EPA REGION 8'S RESPONSE TO PETITION FOR REVIEW

Doc 001, EPA Dewey-Burdock Response to Public Comments,
including descriptions of changes from the 2017 draft to final UIC Class
III and Class V Permits, (November 24, 2020)

Response to Public Comments

Class III Area Permit No. SD31231-00000, Aquifer Exemption Decision

Figure J. Locations of earthquakes occurring between 1872 – 2013 in southwest South Dakota from the South Dakota Geological Survey website.

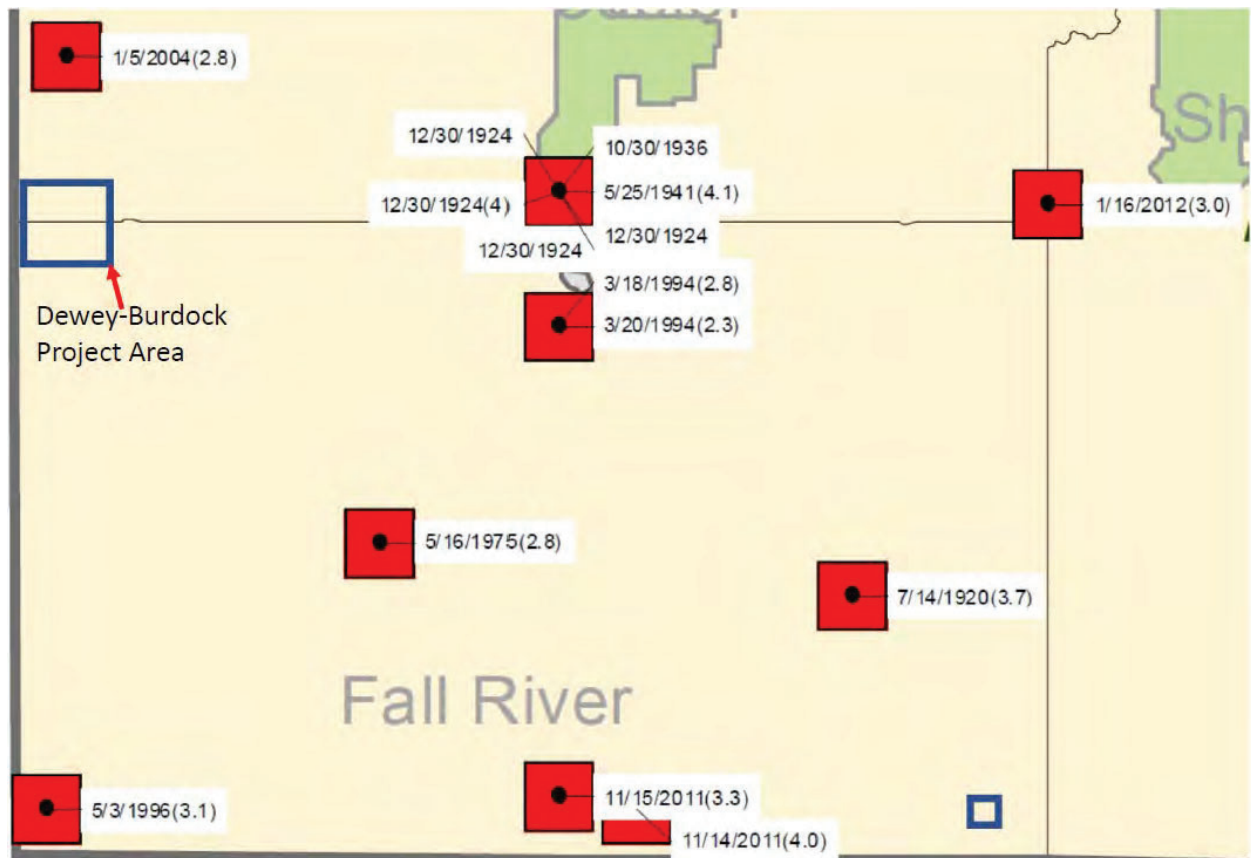
Figure J shows locations of earthquakes that have occurred between 1872 - 2013 in southwestern South Dakota including the earthquakes mentioned by the commenter. This map is available on the [South Dakota Geological Survey website](#).

Figure K. Compilation of the USGS interactive earthquake map and Google maps showing the location of the January 5, 2004 earthquake located at latitude 43.598°N longitude 103.995°W northwest of the Dewey Fault Zone.

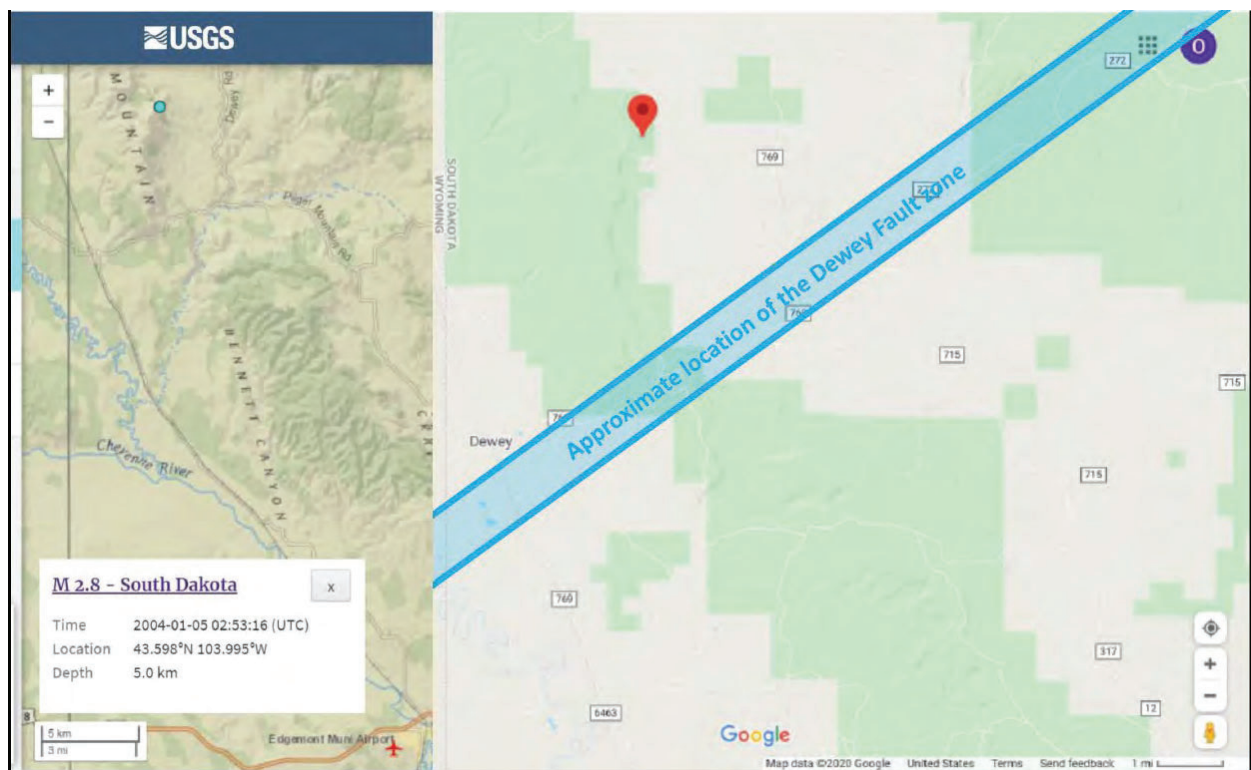
Figure J shows the nearest recorded earthquake to the Dewey-Burdock Project Site is the one that occurred on January 5, 2004, located north of the Project Site. Figure K shows this earthquake location on the [USGS Earthquake Hazards Program interactive map](#). This earthquake was located at latitude 43.598°N and longitude 103.995°W. This location plotted on Google maps with the Dewey Fault zone location added shows that this earthquake was not located in the Dewey Fault zone.

Figure L. The relative locations of the Dewey-Burdock Project Site and Town of Buffalo Gap locations in the Black Hills and Inyan Kara groundwater flow direction.

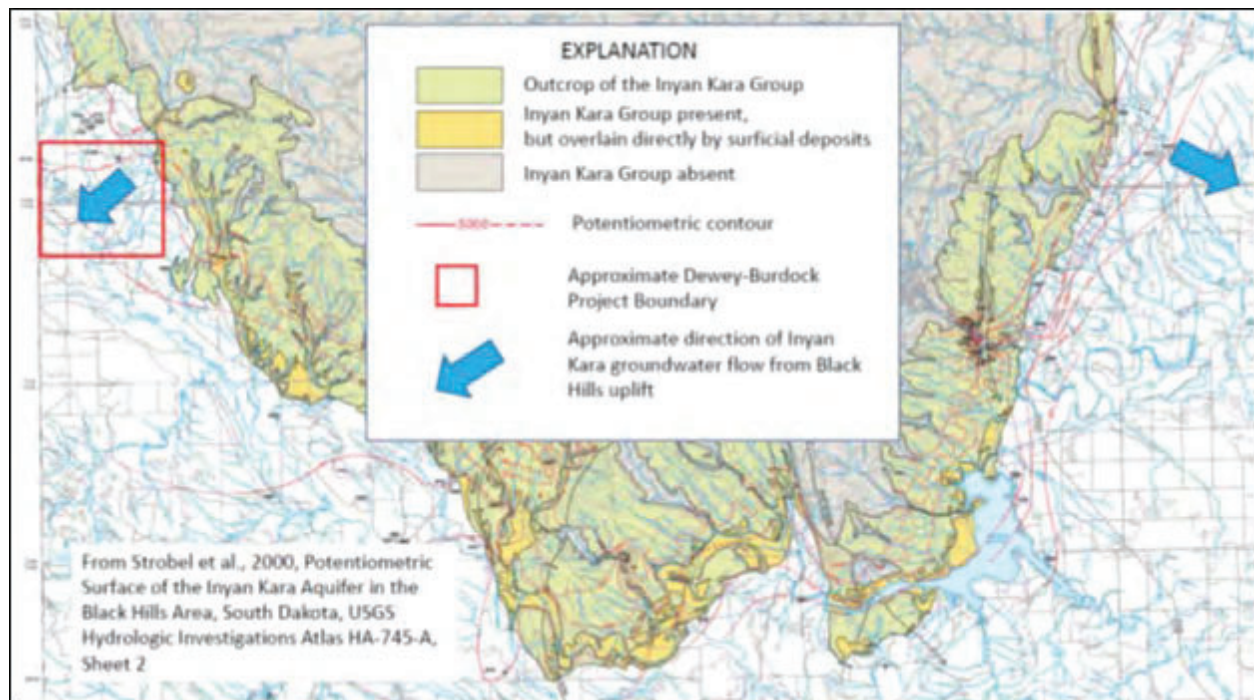
EPA has investigated the injection zone aquifer flow directions from the Dewey-Burdock Project Area relative to the Town of Buffalo Gap, South Dakota. Figure L is the southern portion of Sheet 2 from Strobel et al., 2000, which shows that the Dewey-Burdock Project Site and Buffalo Gap are located on opposite sides of the Black Hills. (Strobel et al., 2000). The Inyan Kara aquifer groundwater flow at the two locations is in opposite directions, as indicated by the potentiometric surface contours that approximately follow the dip of geologic strata away from the Black Hills uplift.

Figure M. Minnelusa aquifer groundwater flow directions around the southern portions of the Black Hills based on Figure 16 from Carter et al., 2001.

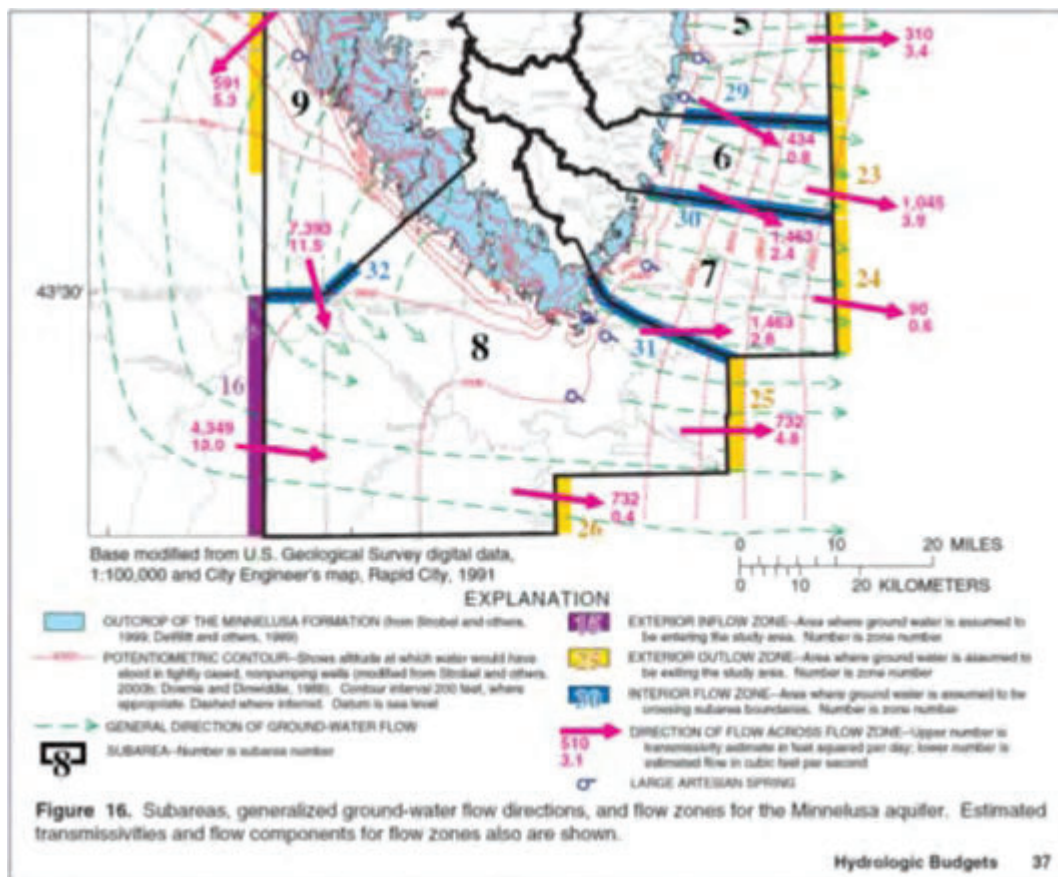
Figure M below shows the groundwater flow directions of the Minnelusa injection zone aquifer at the Dewey-Burdock Project Site and at the Town of Buffalo Gap from Carter et al., 2001, *Hydrologic budgets for the Madison and Minnelusa aquifers, Black Hills of South Dakota and Wyoming, water years 1987-96*: USGS Water-Resources Investigations Report 01-4119. Buffalo Gap is located near the southern border in subarea 7 and the Dewey-Burdock site is located near the pink arrow crossing the boundary between subareas 8 and 9. Based on this Minnelusa aquifer flow direction map, Class V injectate into the Minnelusa aquifer at the Dewey-Burdock project site will not reach the Town of Buffalo Gap.

Based on aquifer flow direction information, the groundwater flowing from the Dewey-Burdock site will not reach Buffalo Gap. Because the proposed Dewey-Burdock operations will have no impact on the aquifers present at Buffalo Gap, EPA does not agree that the geographic scope of the EJ Analysis should be revised to include the Town of Buffalo Gap. For the same reason, EPA does not agree that it would be appropriate to extend enhanced public participation and outreach specifically to the residents of Buffalo Gap.

Figure N. Elevation of the Minnelusa Formation top surface (Source: Carter and Redden, 1999, Sheet 2)

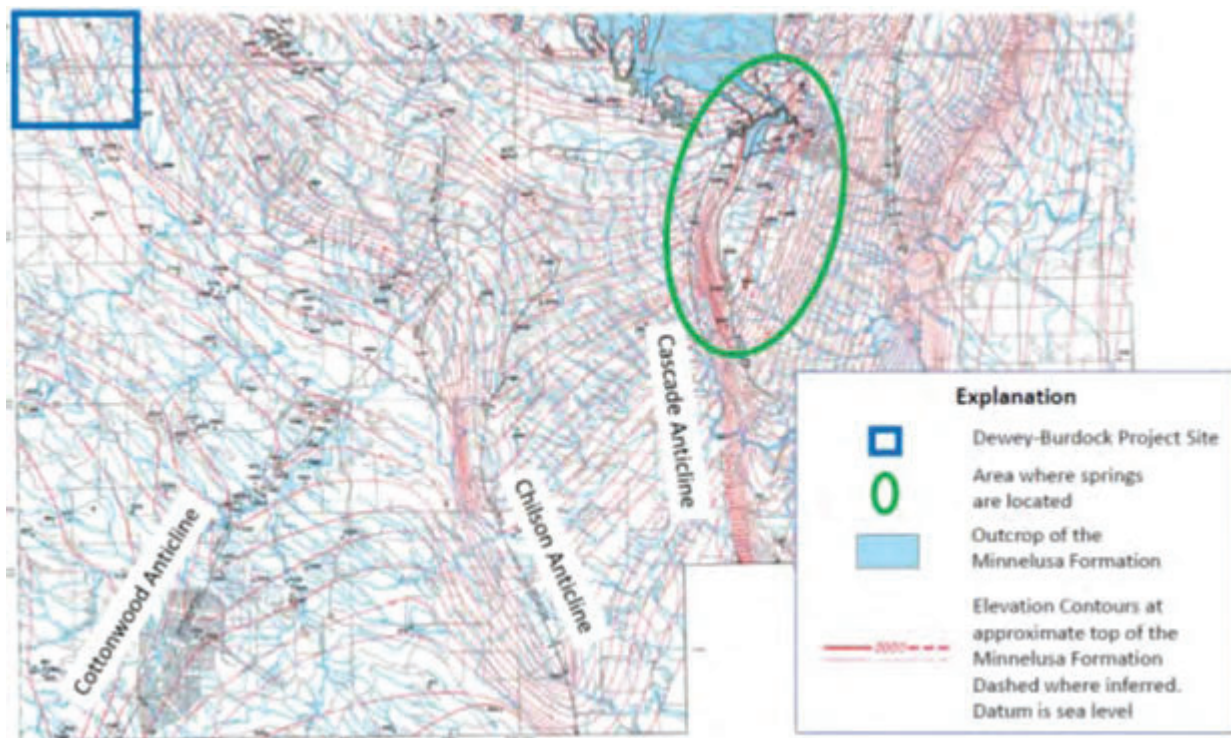
locations where the Minnelusa groundwater flows to the ground surface are at springs near the Minnelusa outcrop around the Black Hills. Figure N shows the elevation of the top of the Minnelusa Formation from the Sheet 2 map from Carter and Redden, 1999. (Carter and Redden, 1999, Sheet 2) The springs are located in the green circle in Figure N; the Dewey-Burdock Project Area is located inside the blue square. The Minnelusa Formation where the springs are located, occurs at a higher elevation than the Minnelusa injection zone in the Dewey-Burdock Project Area. Although the Minnelusa Formation top elevation is not the same as the aquifer groundwater level and the direction of the Minnelusa Formation dip is not exactly the same as the groundwater flow direction, relative formation top elevation and direction of formation dip are a useful approximation in this case. EPA concludes that injectate flowing from the Dewey-Burdock Project Site would have to flow uphill/upgradient to reach these springs and thus would not reach the locations of these springs. In addition, the Cottonwood, Chilson and Cascade anticlines located south of the Black Hills are like hills raising the Minnelusa Formation top to a higher elevation and deflect Minnelusa groundwater flow further south away from the locations of these springs.

Based on this analysis, EPA concludes the Class V disposal well injectate will not travel to the locations of Minnelusa springs to be discharged to the ground surface; therefore, Class V injection activities will not impact surface water, including the Cheyenne River, the Cheyenne River Indian Reservation, the Pine Ridge Indian Reservation, or other downstream communities.

Figure O. Screenshot of the South Dakota Surface Water Quality Standards map (Impairment Status tab) showing drainage basin boundaries as green-dashed lines.

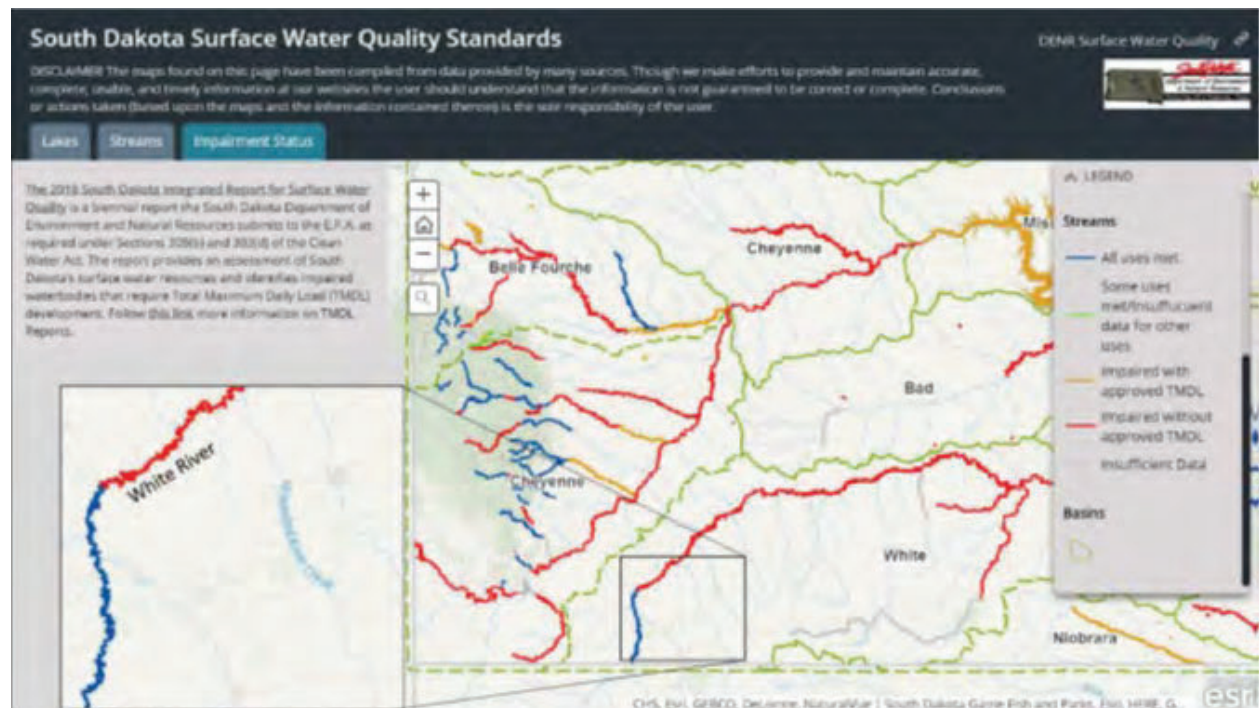
In addition to the explanation above, Figure O below is a screen shot of the South Dakota Surface Water Quality Standards map (click on [Impairment Status](#) tab). The green-dash lines are river drainage basin

boundaries. The enlarged portion of the map shows that Wounded Knee Creek is located in the White River drainage basin. The Dewey-Burdock site is located in the Cheyenne River basin and there is no surface water connection between the Dewey-Burdock Project Site and the White River drainage basin. Based on the geography of the White River drainage basin, it does not receive surface water originating from the Black Hills. Therefore, the Dewey-Burdock Project will not affect the White River drainage basin including the area around Wounded Knee Creek.

Figure P. Minnelusa aquifer groundwater flow direction map from Figure 17, Driscoll et al., 2002

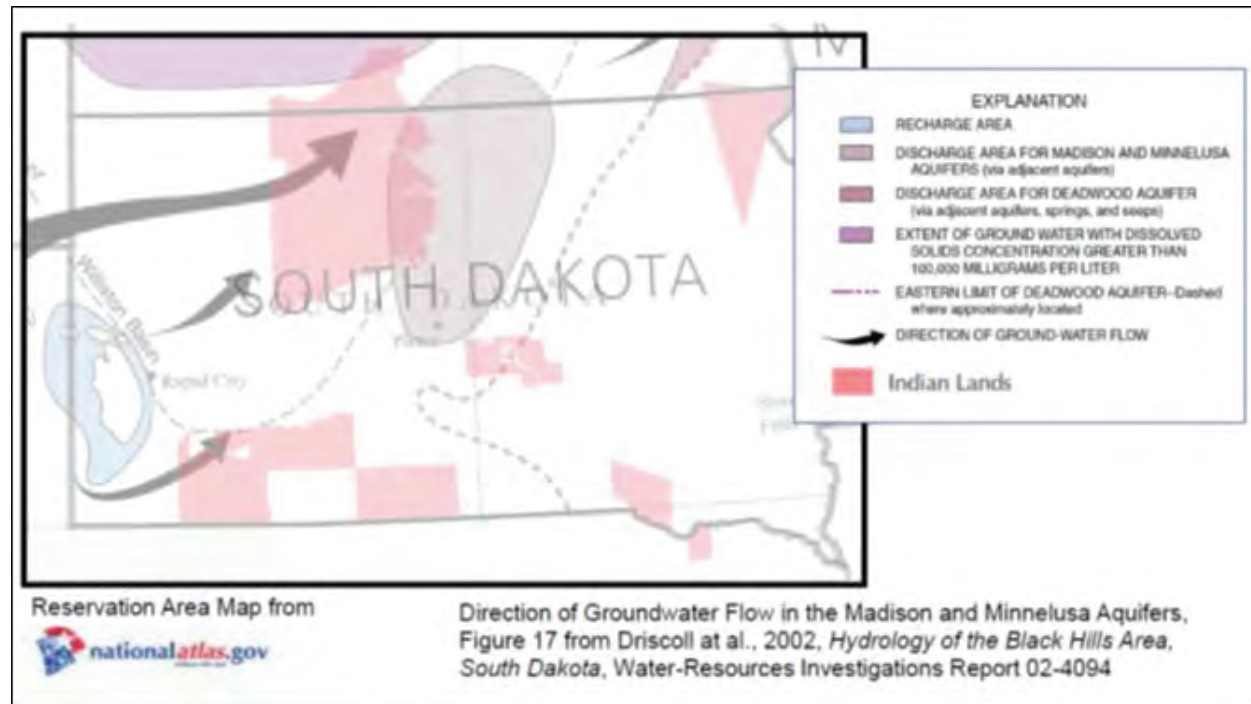
area in the Black Hills to a discharge area identified in this paper. As shown in the map in Figure P, the authors hypothesize that the Minnelusa aquifer groundwater flows from the Dewey-Burdock site and around the southern end of the Black Hills toward the Williston Basin, crossing underneath the northwestern portions of the Pine Ridge Reservation. The map shows a discharge area for the Madison and Minnelusa aquifers in an area that coincides with the eastern portion of the Cheyenne River Indian Reservation.

Figure Q. Locations of springs emanating from or passing through the Minnelusa aquifer, from Figure 8 of Naus et al., 2001.

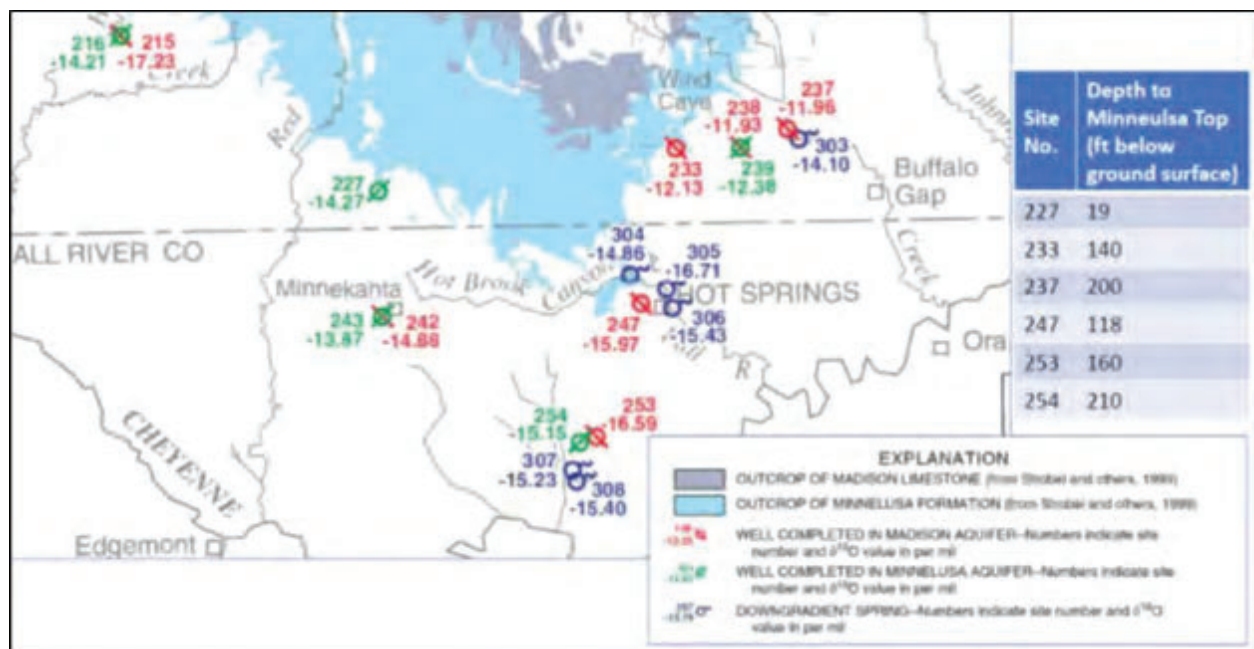
EPA examined oil and gas test wells located near the northwest portion of the Pine Ridge Indian Reservation to determine the depth of the Minnelusa aquifer in the area and found the top of the Minnelusa aquifer is more than 3,800 feet below ground level in this area, which is too deep to flow to ground level. Springs emanating from, or passing through, the Minnelusa aquifer occur where the top of the Minnelusa aquifer occurs closer to the ground level. For example, at the springs shown in Figure Q, from Figure 8 of Naus et al. 2001, the top of the Minnelusa is approximately 200 feet or less below ground level, based on nearby private well logs. Based on the elevation of the top of the Minnelusa Formation shown in Carter and Redden, 1999, the springs occur in areas located at a higher elevation than the Minnelusa injection zone at the Dewey-Burdock Project Site. Carter and Redden, 1999, provides estimates of how the Chilson and Cascade anticlines affect the Minnelusa Formation elevation. As a result, the flow path of Class V injectate would be deflected to the south and would essentially have to flow uphill to reach these springs where Minnelusa groundwater flows to the surface.

Figure R. Map showing area of possible upward leakage from the Madison and Minnelusa aquifers into Inyan Kara aquifers and extent of the Arikaree and Ogallala aquifers (Sources: Peter et al., 1986, Figure 8 and Weeks, et al., 1988, Figure 1)

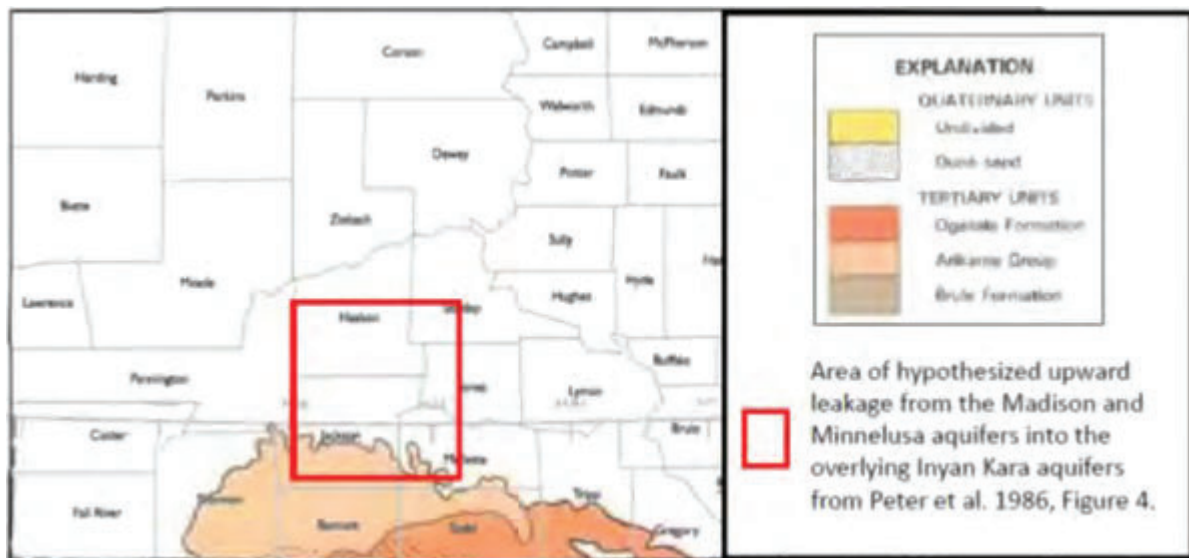
Based on lineament analysis and review of Inyan Kara groundwater quality data, Peter et al., 1986, hypothesized upward leakage from the Madison and Minnelusa aquifers into the Inyan Kara aquifers in an area within portions of Jackson, Melette, Haakon, Stanley and Jones Counties in South Dakota. (Peter, K.D., et al., 1986, *Lineaments: Significance, Criteria for Determination, and Varied Effects on Ground-Water Systems—A Case History in the Use of Remote Sensing*, Geotechnical Applications of Remote Sensing and Remote Data Transmission, ASTM STP 967, A. I. Johnson and C. B. Pettersson, Eds., American Society for Testing and Materials, Philadelphia, 1988, pp. 46-68.) Figure R shows the location of this area overlaid on a map of the Arikaree and Ogallala aquifers in South Dakota documented in Weeks, et al., 1988. (Weeks, J.B., et al, 1988, *Summary of the High Plains Regional Aquifer-System Analysis In Parts of Colorado, Kansas, Nebraska, New Mexico, Oklahoma, South Dakota, Texas, and Wyoming*, USGS Professional Paper 1400-A, at p. A4) Upward leakage from these lower aquifers into the Inyan Kara aquifers does not necessarily result in upward leakage into the overlying Arikaree and Ogallala aquifers in this location. EPA reviewed logs from oil and gas test wells in Jackson County and determined the top of Inyan Kara is 2800 to 2900 feet below ground surface. Approximately 2000 feet of overlying strata, most of which are confining zones, separate the top of Inyan Kara aquifer from the Arikaree and Ogallala aquifers. EPA concludes that Inyan Kara groundwater does not flow into the Arikaree and Ogallala aquifers on the Pine Ridge Indian Reservation.

EPA has investigated the area identified as a discharge area for the Minnelusa and Madison aquifers in the area shown in Figure P that coincides with the eastern portion of the Cheyenne River Reservation. The discharge area represents the area where Madison and Minnelusa groundwater is moving upward into the Inyan Kara aquifers (Downey, J.S and Dinwiddie, G.A, 1988, *The Regional Aquifer System Underlying the Northern Great Plains in Parts of Montana, North Dakota, South Dakota, and Wyoming-Summary*, USGS Professional Paper 1402-A). Based on oil and gas test well logs EPA reviewed, the depth to the top of the Minnelusa aquifer in the area of discharge is approximately 3,000 feet below ground level and the top of the Inyan Kara aquifer is approximately 2,000 feet below ground level. According to Howells, 1979, (Sheet 1) the Pierre Shale is present at the surface of the eastern portion of the Cheyenne River Indian Reservation. (Howells, L., 1979, *Geohydrology of the Cheyenne River Indian Reservation, South Dakota*, USGS Hydrologic Investigations Atlas HA-585, Sheet 1) Most of the intervening geologic units between the top of the Inyan Kara, including the Pierre Shale, are confining units. Based on this information, EPA concludes that neither the Minnelusa nor the Inyan Kara injection zones discharge to ground level at the Cheyenne River Indian Reservation. EPA examined test oil and gas well logs and found that along the eastern edge of the Cheyenne River Indian Reservation the top of the Inyan Kara ranges from 1500 in the southeast to 2800 in the northeast. The top of the Inyan Kara deepens from south to north as it descends further into the Williston Basin. Driscoll et al., 2002, characterizes Inyan Kara groundwater as moderately saline with increasing salinity toward the deep parts of the Williston and Powder River Basins. Because of the depth and salinity of the Inyan Kara aquifers at the Cheyenne River Indian Reservation, these aquifers would not be developed for use.
